SUBJECT: Calvert Cliffs Nuclear Power Plant  
Unit Nos. 1 & 2; Docket Nos. 50-317 & 50-318  
Request for Amendment

CHANGE NO. 1 (BG&E FCR 88-63)

Plant Computer Inverter Replacement

SLD VITAL 120V A.C. & 125V D.C.  
EMERGENCY 250V D.C.  
FSAR FIG. NO. 8-5

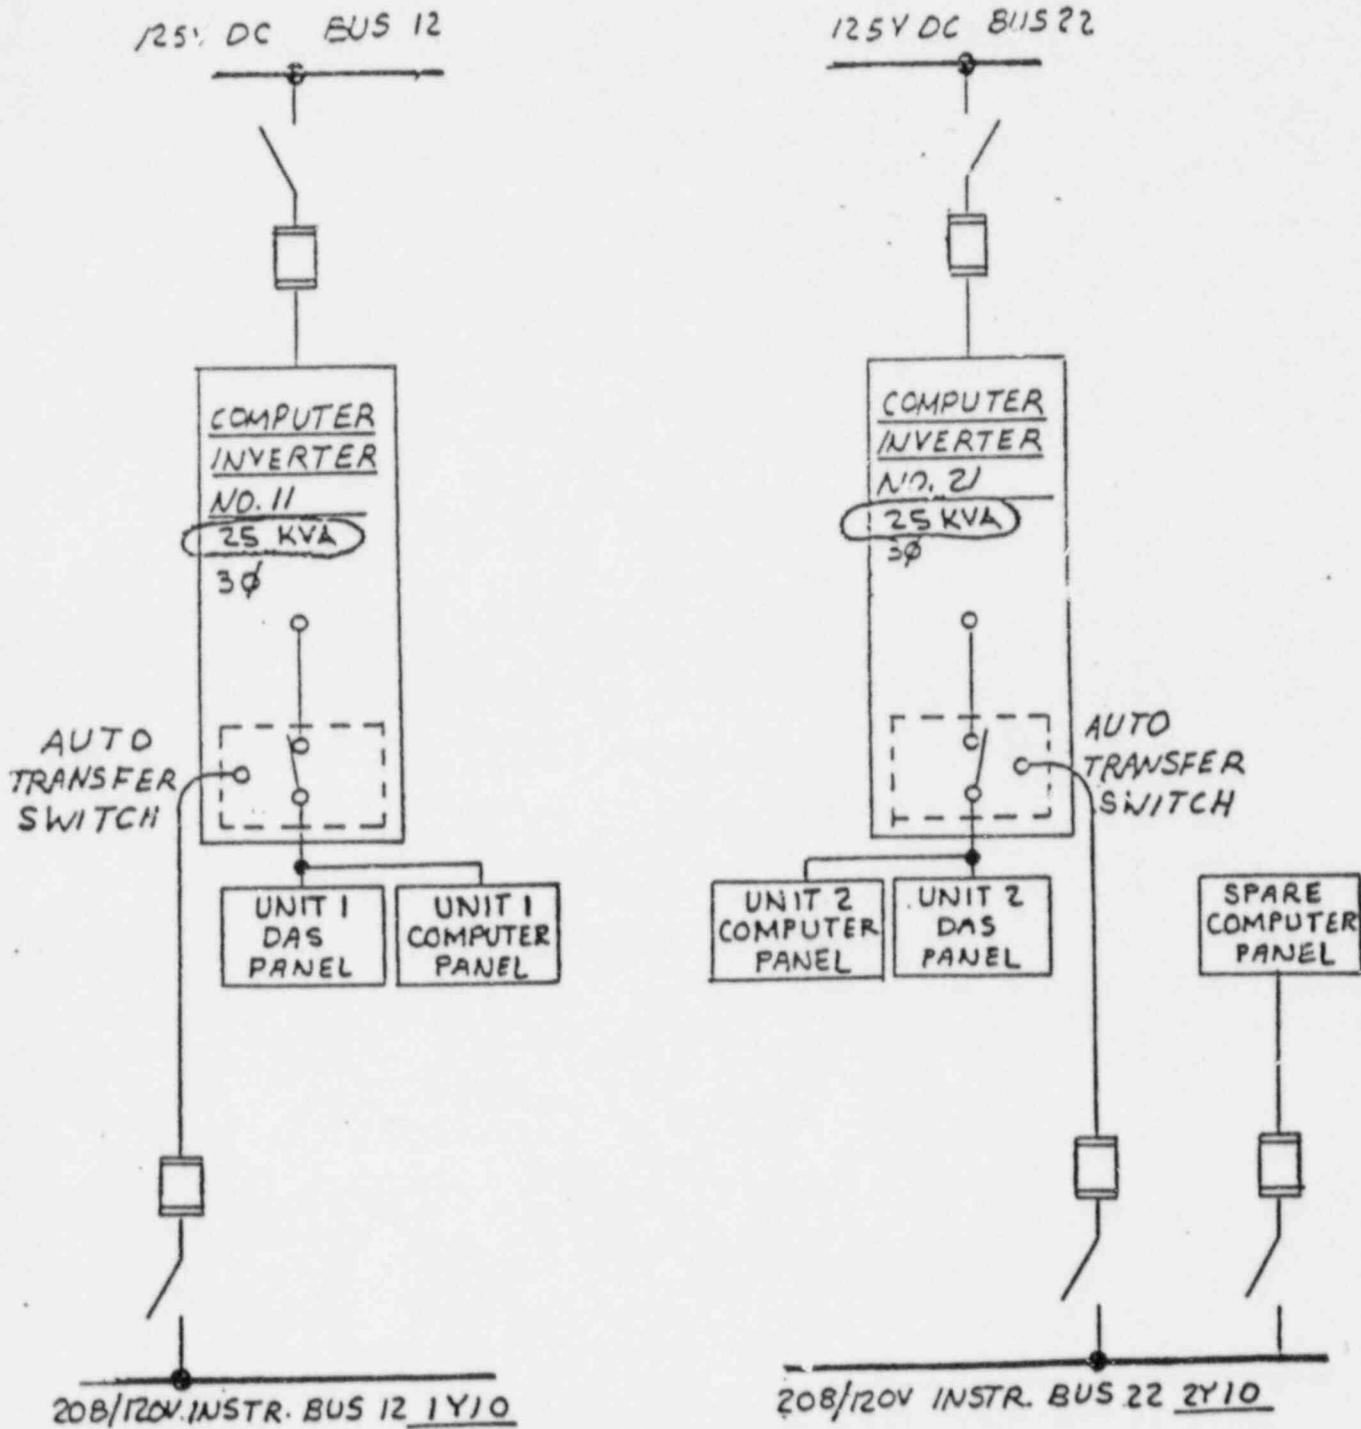
The battery loadings will increase because of the larger computer and inverter. The new dummy load profile for batteries 12 and 22 is:

The existing design function and the operation of the plant computer and DAS will remain unchanged. All FSAR design criteria will be met. The station batteries will be able to provide the necessary power for two hours after a loss of AC power. The design of the inverter system is essentially unchanged. This is not a change to the surveillance test. The test procedure will only be changed to require a new and more stringent discharge capacity. Therefore, no new or different accidents will be created. A sketch of the modification both before and after is attached.

The 15 KVA computer inverters are being replaced with 25 KVA models. This is necessary to handle the additional load required by the new plant computer and DAS. This additional load will require a greater discharge from batteries 12, 22 and possibly the Reserve Battery in case of a loss of AC power. However, the No. 12 and 22 Battery capacity for the new duty cycle is 129% of what is required. The Reserve Battery capacity for the new duty cycle is 105% of the required. A significant amount of reserve capacity beyond what is required is still available.
